## **TECHNICAL BULLETIN**

**412-24-250**  
31 October 2024

**MODEL AFFECTED:** 412EP

**SUBJECT:** BLEED AIR DUCT CLAMP, REPLACEMENT OR REWORK OF

**Figure 1  
 Bleed Air Duct Installation**

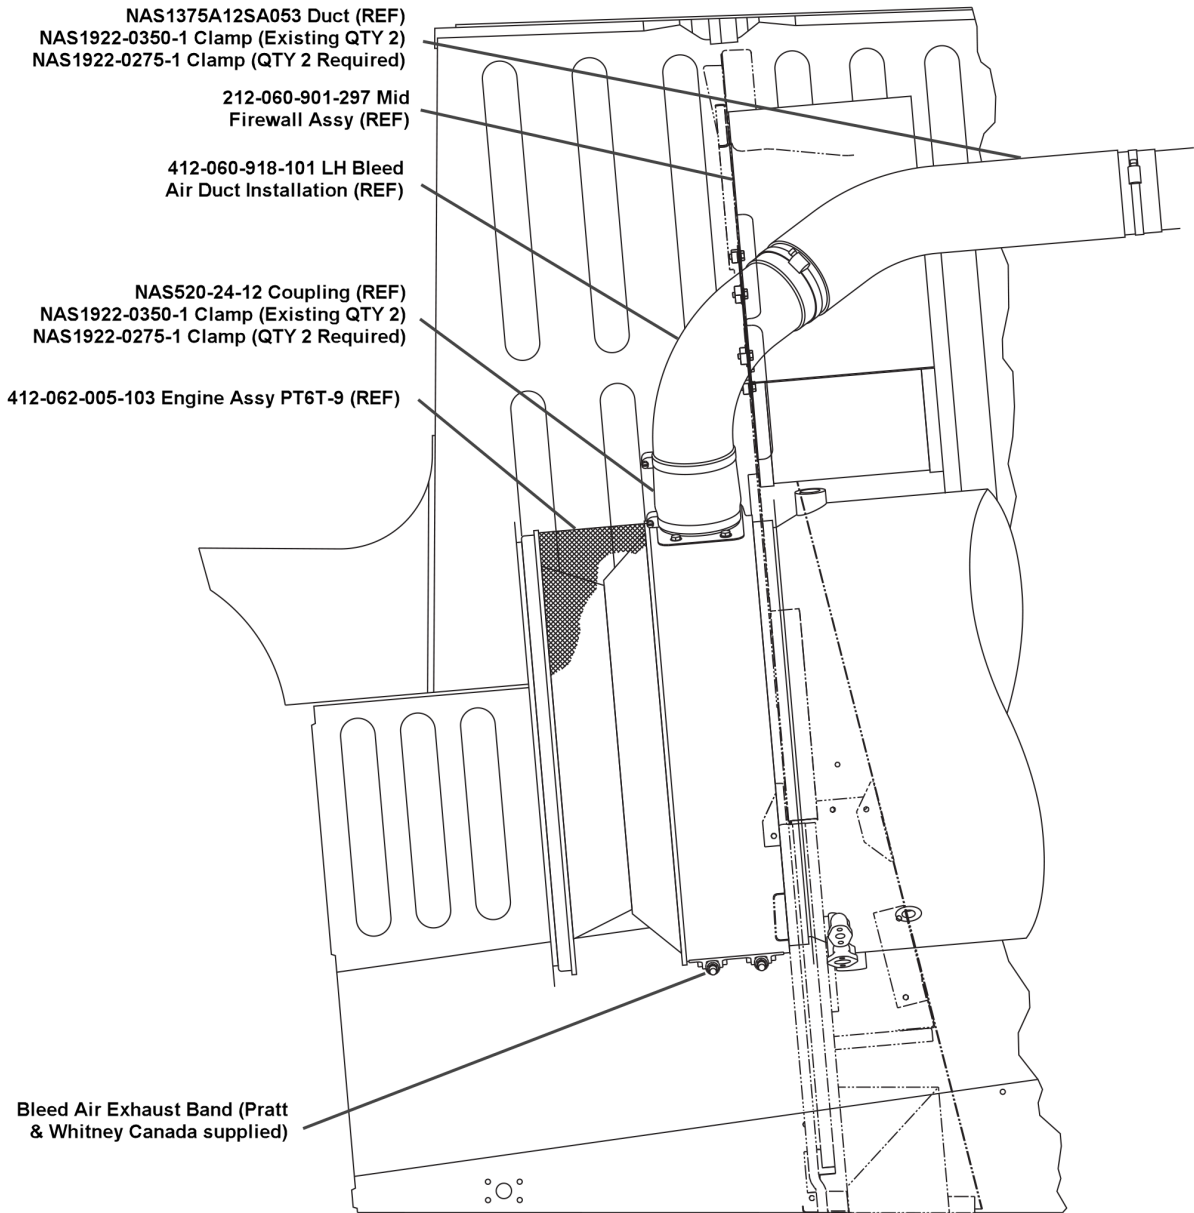
Bell has discovered that clamps NAS1922-0350-1, used in the bleed air duct installations 412-060-918-101/-102, are too large and in some cases the "tail" of the clamp failed in service due to vibration causing a possible foreign object debris (FOD) condition. This technical bulletin provides instructions to either trim the excess material or replace the existing clamps with smaller clamp NAS1922-0275-1.

Figure 1 shows the LH duct installation 412-060-918-101, RH duct installation 412-060-918-102 is similar.

2. Gain access to the LH duct installation 412-060-918-101 (Refer to Figure 1).
3. Inspect the four existing clamps NAS1922-0350-1 for excess material, more than 0.25 inch (6.35 mm), beyond the clamp screw mechanism.
  - a. If the clamp has excess material:
    - (1) Either cut off the excess material and trim the sharp edges or replace with smaller clamp NAS1922-0275-1.
  - b. If any of the existing clamps NAS1922-0350-1 excess material has broken off:
    - (1) Inspect the engine compartment for the broken off material.

(3) Either trim the sharp edges or replace with smaller clamp NAS1922-0275-1.

4. Gain access to the RH duct installation 412-060-918-102 (Refer to Figure 1).
5. Repeat step 3.
6. Make an entry in the helicopter logbook and historical service records indicating compliance with this Technical Bulletin.
